Addendum #1

May 3rd, 2022

Re: **Addendum No. 1**
Garner Main EMS
845 Thompson Road
Garner, NC 27529
ADW Job No. 20004
Wake County Bid #22-030

ELECTRIC RANGE AND GAS GRILL SHUT OFF DETAIL | NO SCALE | 01

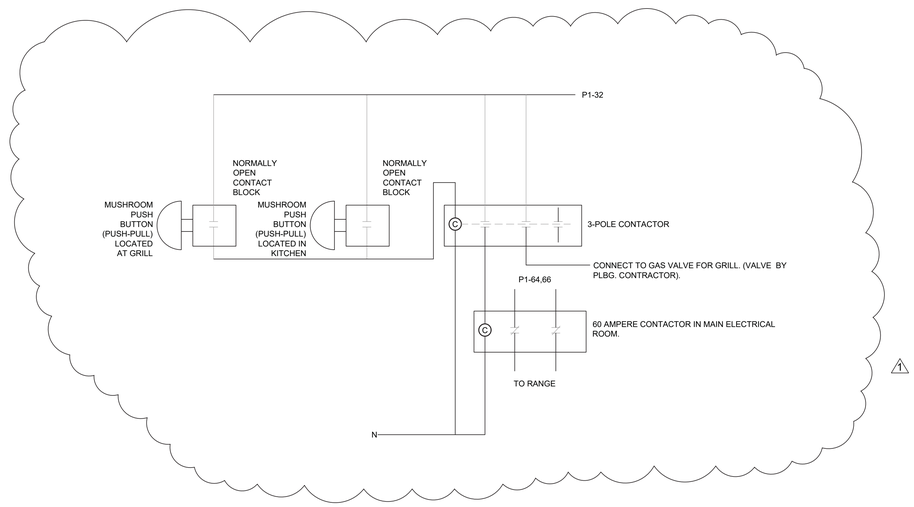
b. Keynote #1 to read as follows: ELECTRIC RANGE AND GAS GRILL SHUT-DOWN SYSTEM. PROVIDE SHUT-DOWN BUTTON AT THIS LOCATION. REFER TO DETAIL 1/E502.
c. Keynote #3 to read as follows: ELECTRIC RANGE AND WALL MOUNTED MICROWAVE WITH RANGE EXHAUST. REFER TO A-SERIES FOR MNT. HTS.

13.) Sheet E502:
a. Changes to detail 1/E502 related to electric range and gas shut-off.

SPECIAL SYSTEMS PLAN 1/8" = 1'-0" 01

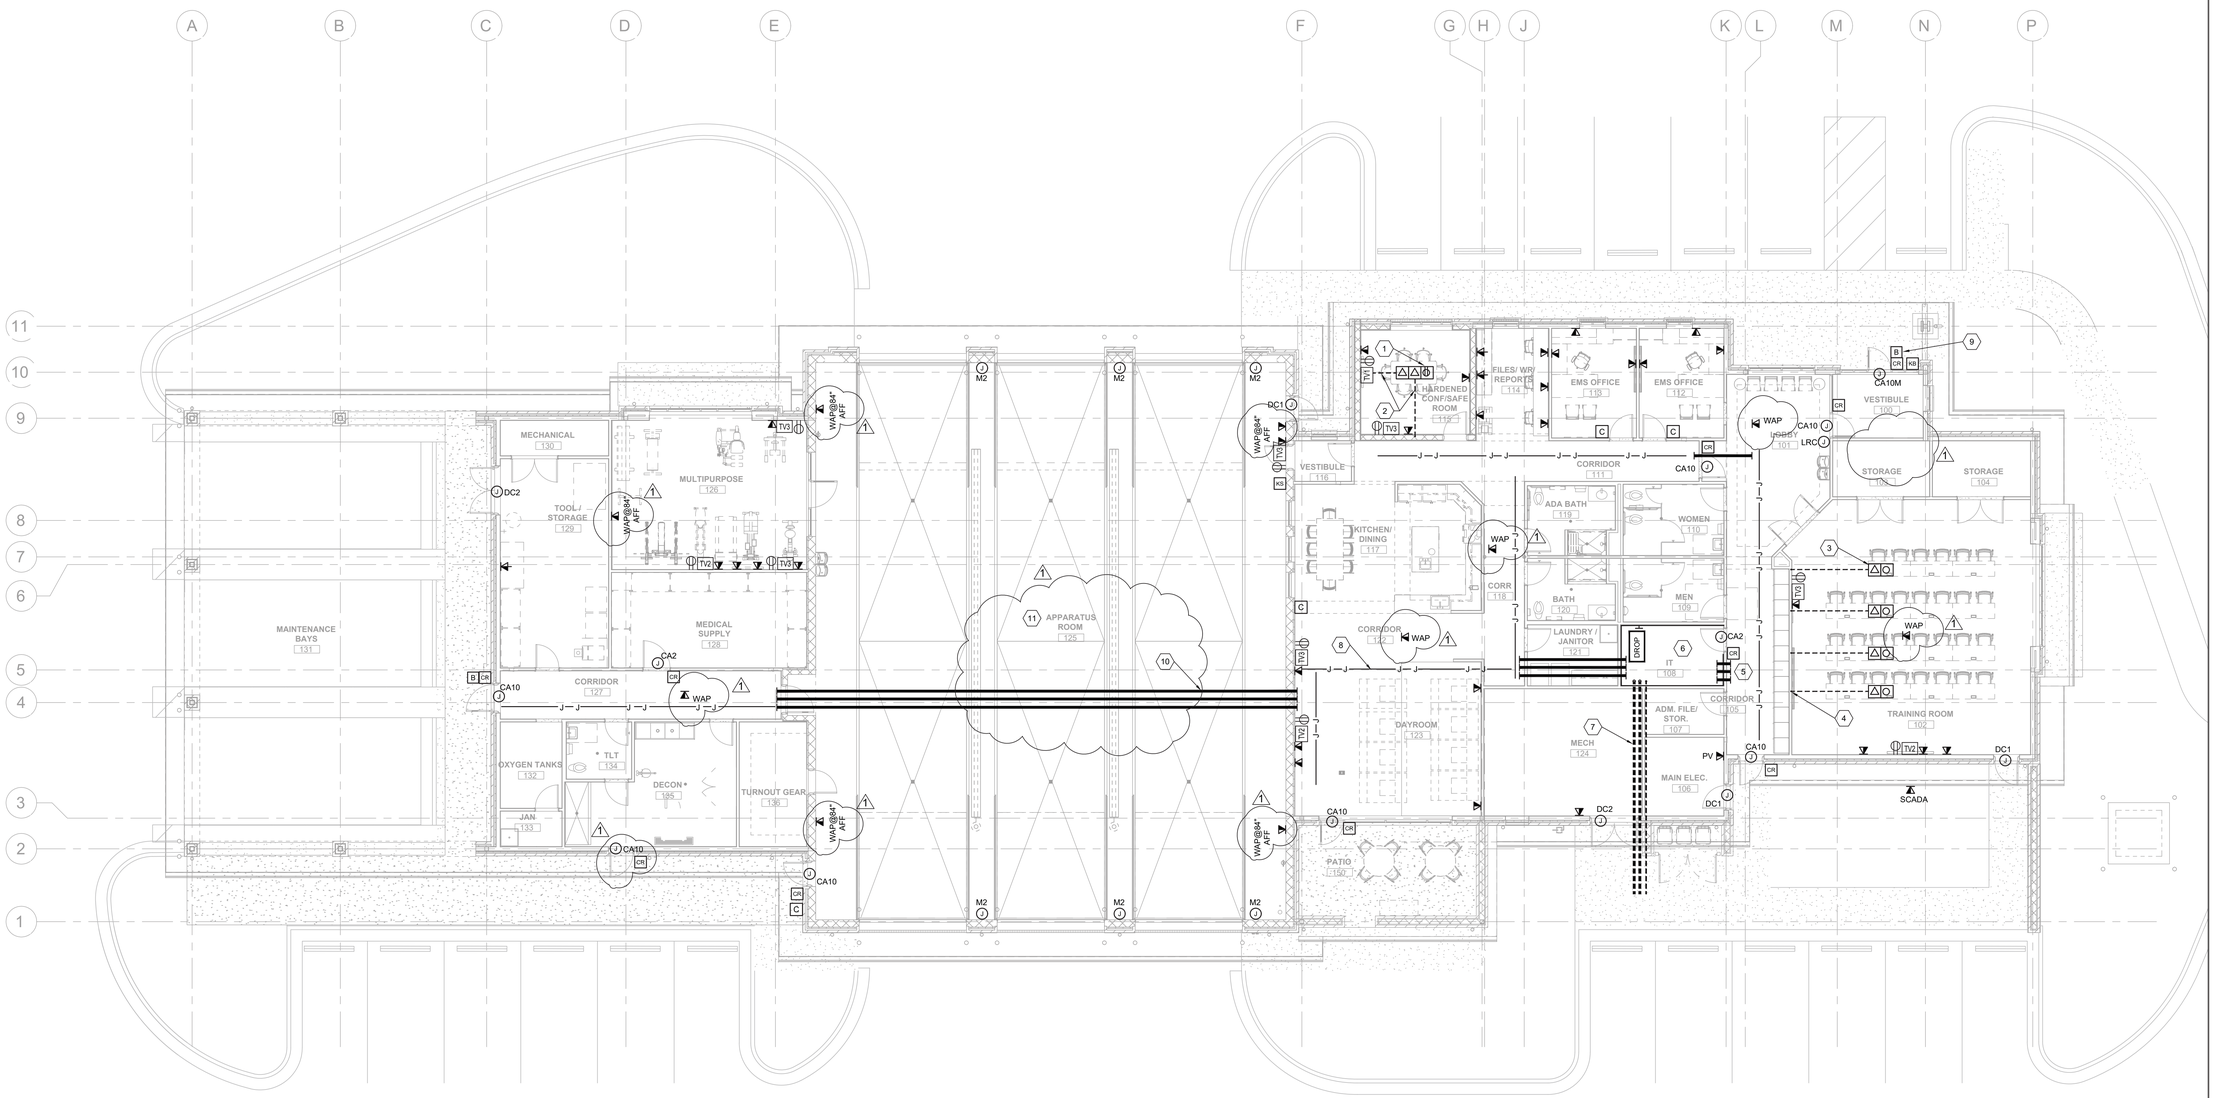
15.) Sheet SS200:
a. Miscellaneous changes related to WAP mounting and wiring methods in Apparatus Bay.
